Q-1. In order to properly design the specular materials for the side walls, floor and ceiling of the chamber it is imperative that the source antenna gain, beam width and pattern characteristics be known

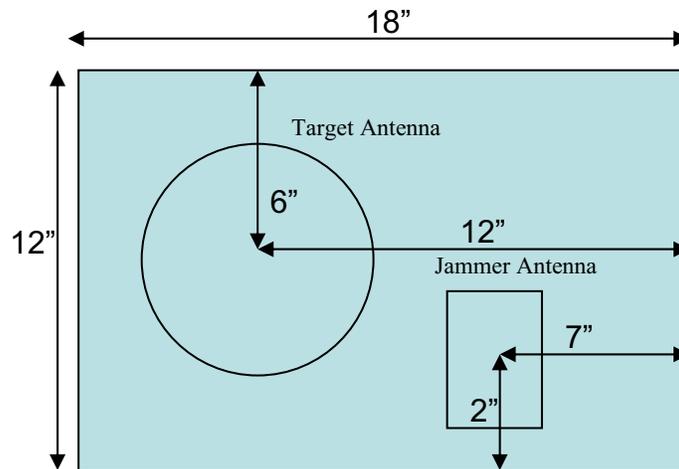
Q-2. In addition to the source antenna characteristics the exact proximity to the sidewalls, floor and ceiling must be known. In amendment 2 of the specification it is stated that the source antenna moves in a "square area 18" wide x 12" high located on the centerline of the back wall". During the site visit it was seen that the antenna is located on the center of the height of the back wall but was not located in the center of the back wall width. What is the location of the center of the source antenna with respect to the width of the chamber back wall?

A-2. The antennas mentioned above are located on the drawing below:

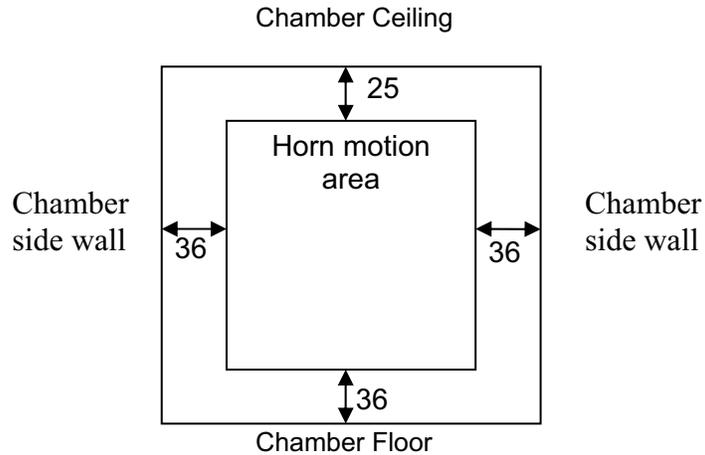
Q-5. Without the antenna probe device being active at the site visit the full motion of the probe antenna was not evident. The simple question is: How close to the chamber surfaces does the source antenna travel?

A-5. The traveling antenna moves in the area shown below. The antenna is a Scientific Atlanta, model 12-7.0.
